Index 700-120 Enhanced Highway Signing Assemblies

COMMENTARY

COMMENTS AND RESPONSES

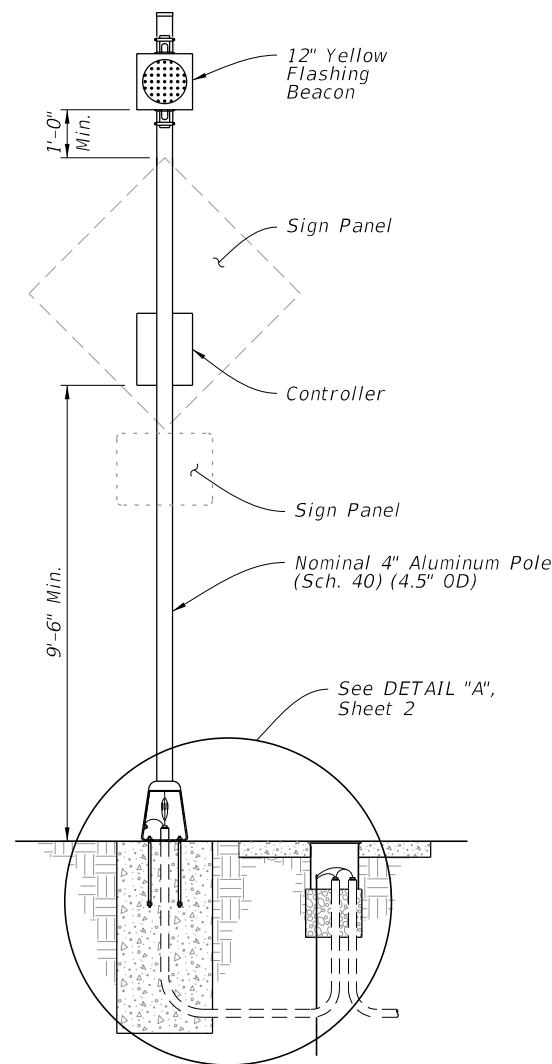
COMMENT: Has the revision of pole diameter callouts from 4" nominal to 4.5" OD been properly coordinated? This change could incur cost updates and other design considerations and affect APL. Were structural parameters considered? Specification 646 references 4" nominal which needs to be updated.

RESPONSE: The pole/posts are not changing with this update so there are no issues with the APL or additional costs incurred. This change was requested by the Structures Office to make callouts consistent with other Indexes that specify pole/post dimensions. The 4" nominal and

4.5" OD are the same callout in this scenario based on ASTM B429 which is a requirement of Spec 646. Although there is no conflict, Spec 646 will be updated to be consistent with the new callout in Indexes 646-001, 654-001, 695-001, and 700-120. The callout in the indexes will be updated to clarify that the poles/posts are not changing.

Change Made: Revise callouts in the Indexes and Spec to read "Nominal 4" Aluminum Pole (Sch. 40) (4.5" OD)"

SHEET
 1 of 11

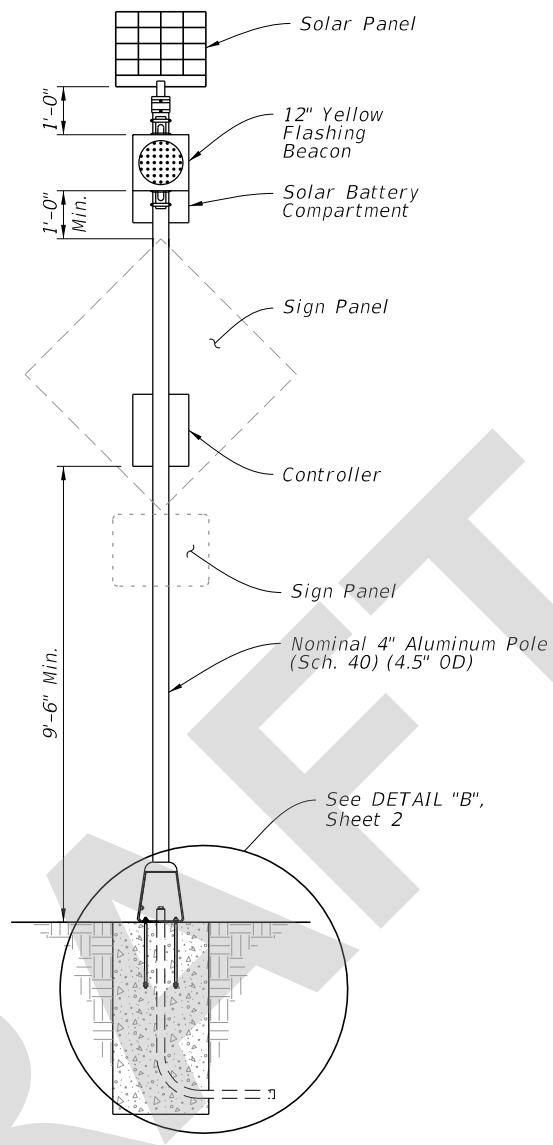
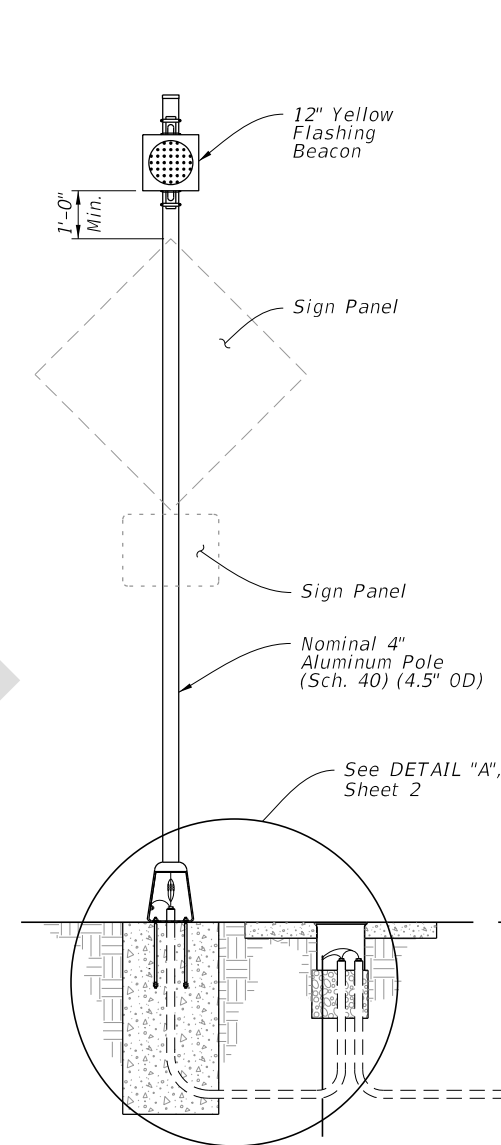
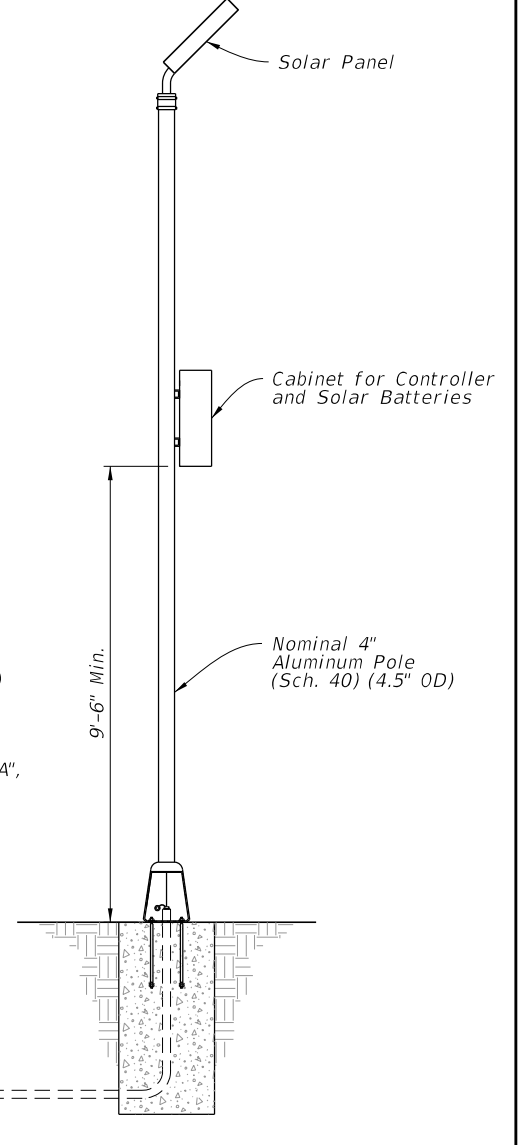
COMMENT: Draft page 1/11: Note # 5 advise concrete slab around light pole on road side – screen shot

[5. Install a concrete slab around all roadside assemblies on slopes 6:1 or greater. The minimum slab dimension is 6' by 4'-0" by 5'-0".

Comment:- please specify whether Non structural concrete could be used for this.

RESPONSE: The new General Note 4 references the material requirements of Specification 646. The material criteria including Concrete requirements are included in Specification 646.

No Change Made
